DEVELOPMENT REVIEW BOARD  
SUPPLEMENTAL SUBMITTAL

PROJECT NO. PR-2021-006070  
Application No. SI-2021-01888

**Re:** Westpointe40 South Site Plan DRB Comment Responses (PR-2021-006070)

This memo outlines the responses and changes made to the site plan for the proposed 60K warehousing and distribution building at Westpointe40 based on the comments received and reviewed at the December 1, 2021 DRB meeting. The comments are numbered and followed by the response in italics.

<b>BLUE SKY DISTRIBUTING</b> ALBUQUERQUE, NM	DRAWN BY pm DATE 12-6-21
	<b>SITE PLAN FOR</b> <b>BUILDING PERMIT</b>	DRAWING 2020088-60K.DWG
RONALD R. BOHANNAN P.E. #7868	 5571 MIDWAY PARK PL NE ALBUQUERQUE, NEW MEXICO 87109 (505) 858-3100 www.tierrawestllc.com	SHEET # <b>SP-1</b> JOB # 2020088

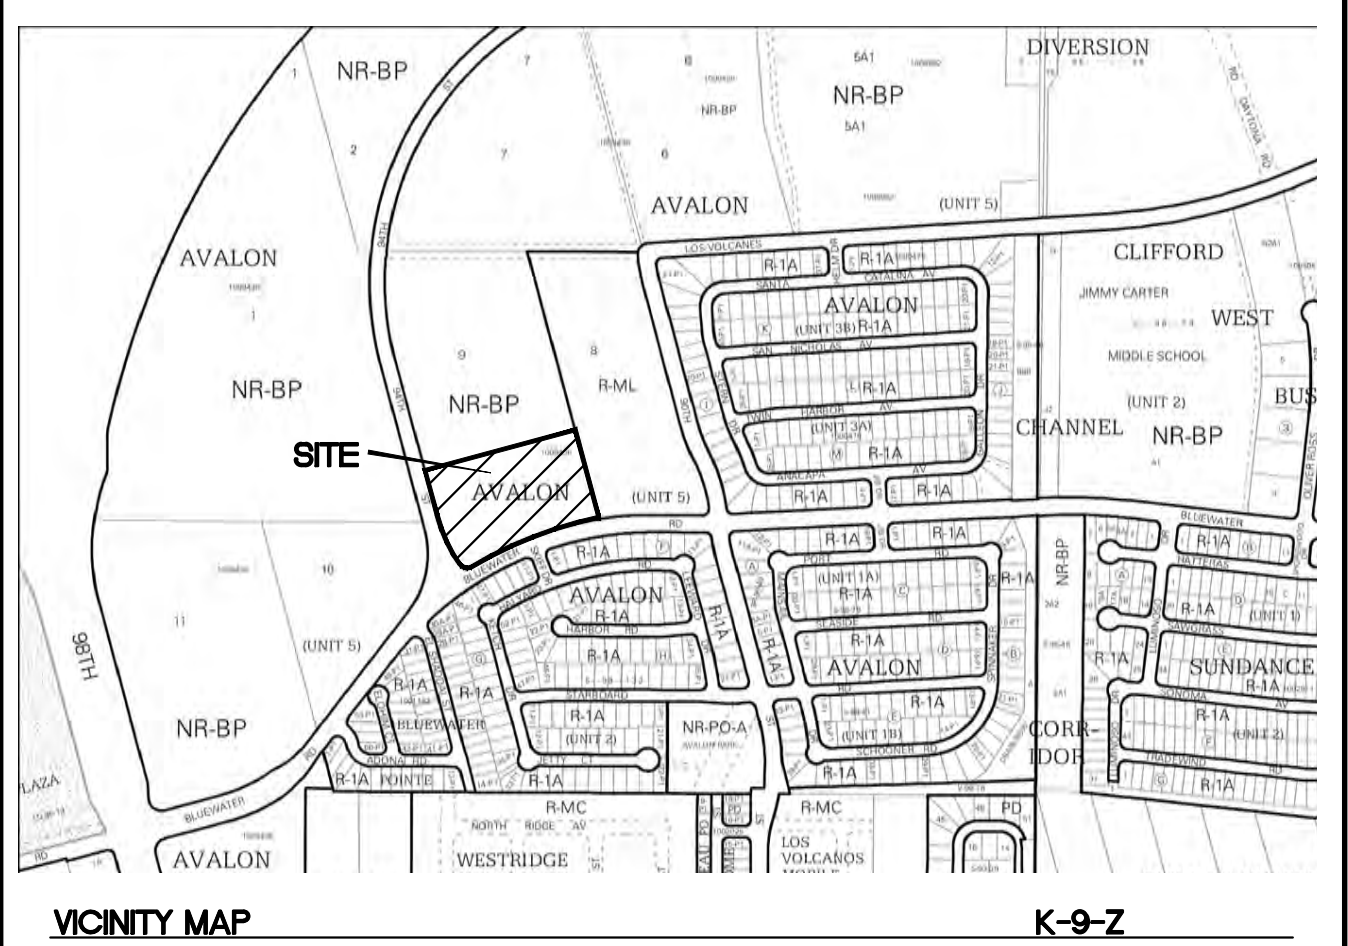
- *Understood. The project has been designed to comply with the NR-BP zone district regulations.*
3. Dimensional standards per IDO section 5-1. Clarify different setback notes on plat.

7. Additional detail needed for meeting outdoor lighting. IDO section 5-8.
  - *Keynote 7 identifies the site lighting with a maximum height of 30 feet tall. This is the maximum height allowed per Table 5-8-1 when located far enough away from adjacent residential zones.*

- *Please see the response to Code Enforcement comment #8.*
5. The building setbacks are depicted on the Site Plan as 5-feet for the front, and 0-feet for the sides and rear. The setback requirements in the NR-BP zone district are 20-feet for the front, and 10-feet for the sides and rear. The setbacks for the buildings based on the NR-BP standards appear to be met. Confirm that the setbacks are being met and note the correct required setback standards and the setbacks for the proposed buildings on the Site Plans.

- *The setbacks on the site plan have been updated to correctly reflect the NR-BP zone district standards, and the plan complies with these setbacks.*

- *The setbacks have been updated on the site plan.*
6. The Site Plan for the southern portion of the site featuring the proposed 60,573 square foot building is phased, with 22,050 square feet of future expansion depicted. Confirm if the improvements and infrastructure depicted on the Site Plan for the southern portion of the site will be phased as well or if the improvements and infrastructure will be constructed in their entirety as depicted on the Site Plan during the first phase.

**UNIDIRECTIONAL HC RAMP**  
NOT TO SCALE

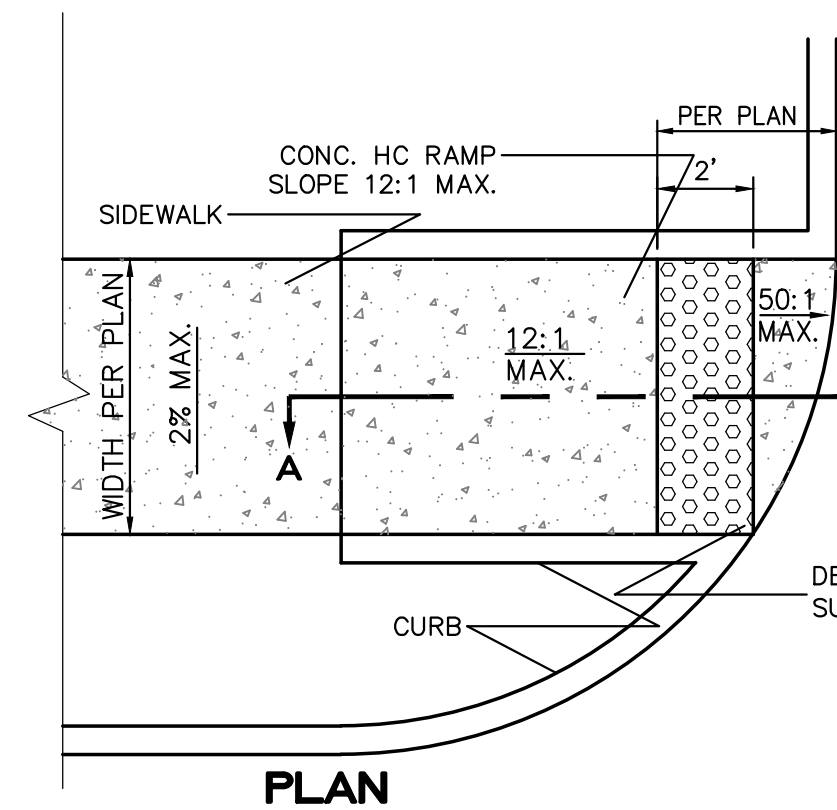
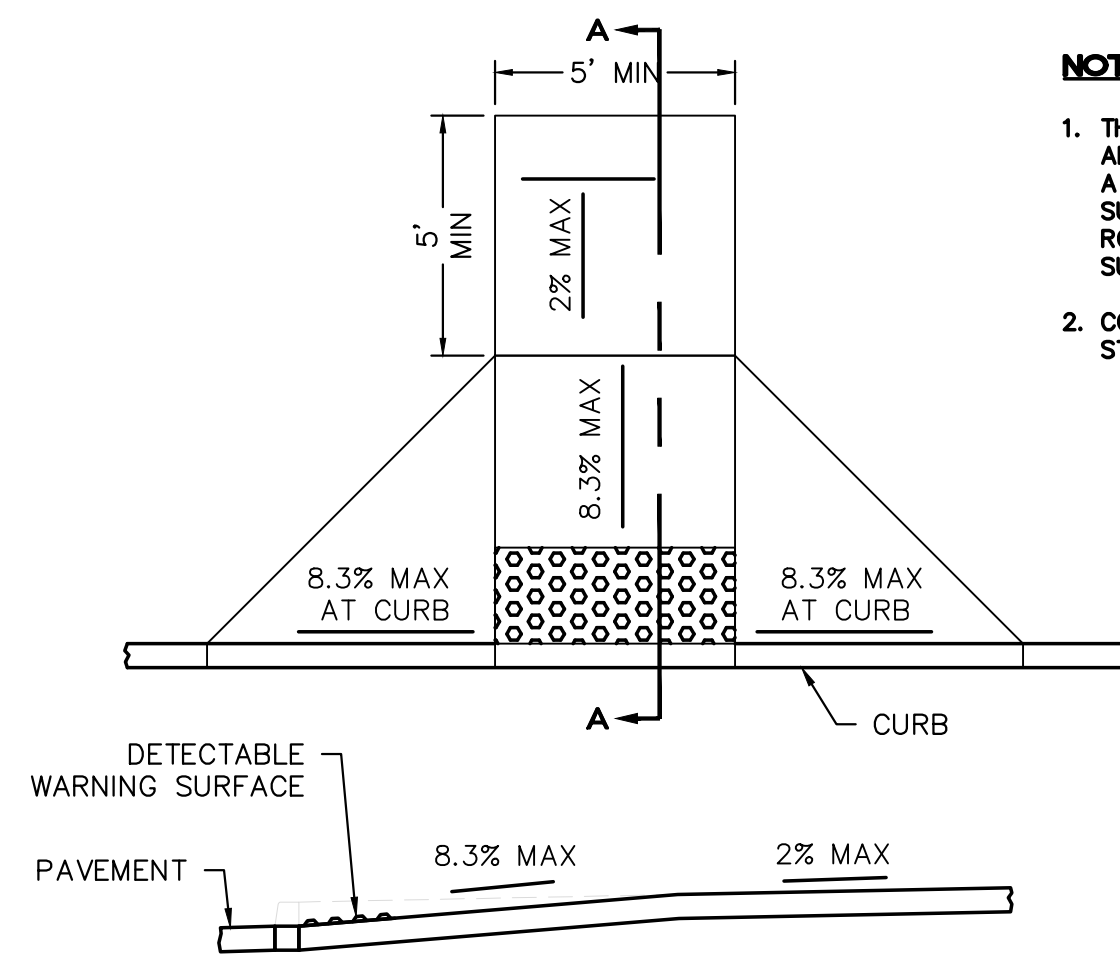
- *Fire 1 plan will be submitted for the final plan set.*
  7. Include the Det-1 sheet with all required details such as sidewalk, bike rack, curb ramps, curb, handicapped parking and signage, motorcycle signage, etc.

- *These details have been added to the plan set.*
  8. Is there sufficient room to fit in the exact curb ramp configuration at the van accessible aisles including the ramp and sidewalk? With at least one location, it does not appear as though there will be sufficient space behind the ramp for turning space for a wheelchair.

- *The accessible space and ramp locations have been modified to allow for the appropriate turnaround.*

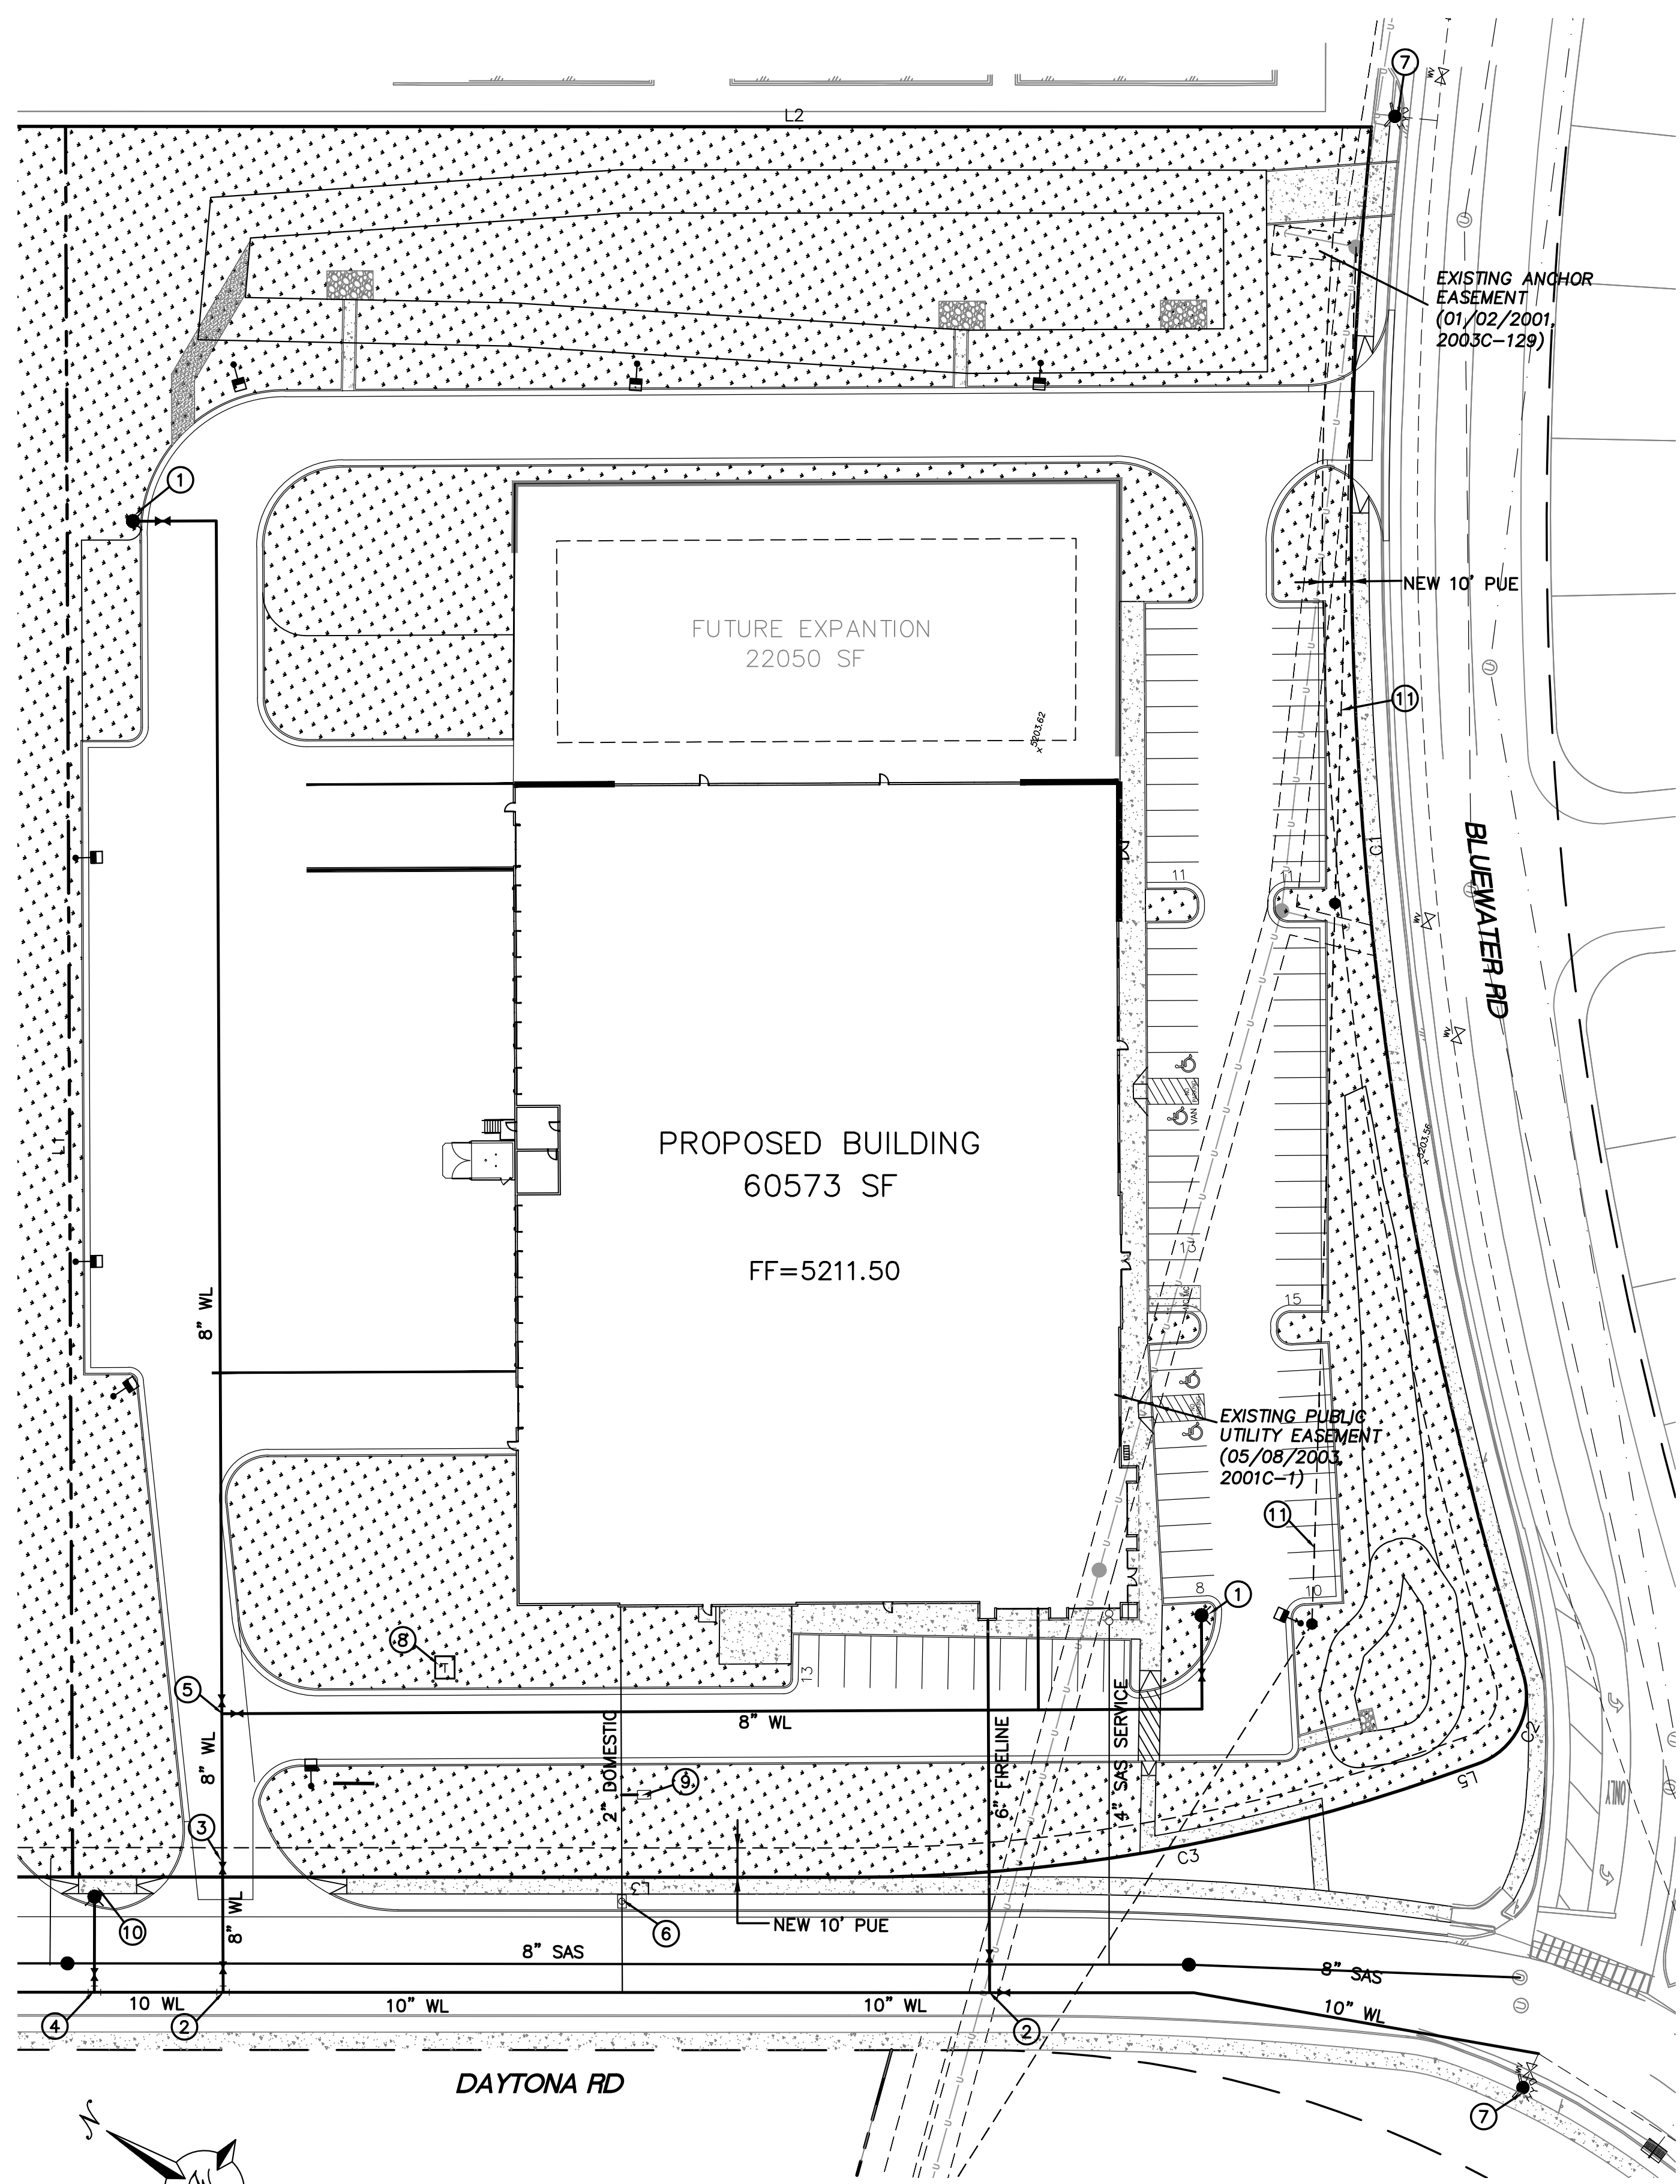
2. This project is within the adopted service area.
3. Pro rata is not owed for this property.
4. Utility Plan:
  - a. The meters need to be at the right-of-way line. The WUA will not maintain a line onsite to shorten the private water line lengths. Separate service connections are required for each meter.

- b. The required water main has been revised to a ten-inch. Please revise the call-out to be consistent with this requirement.
    - *An updated utility plan has been provided with the supplemental submittal.*
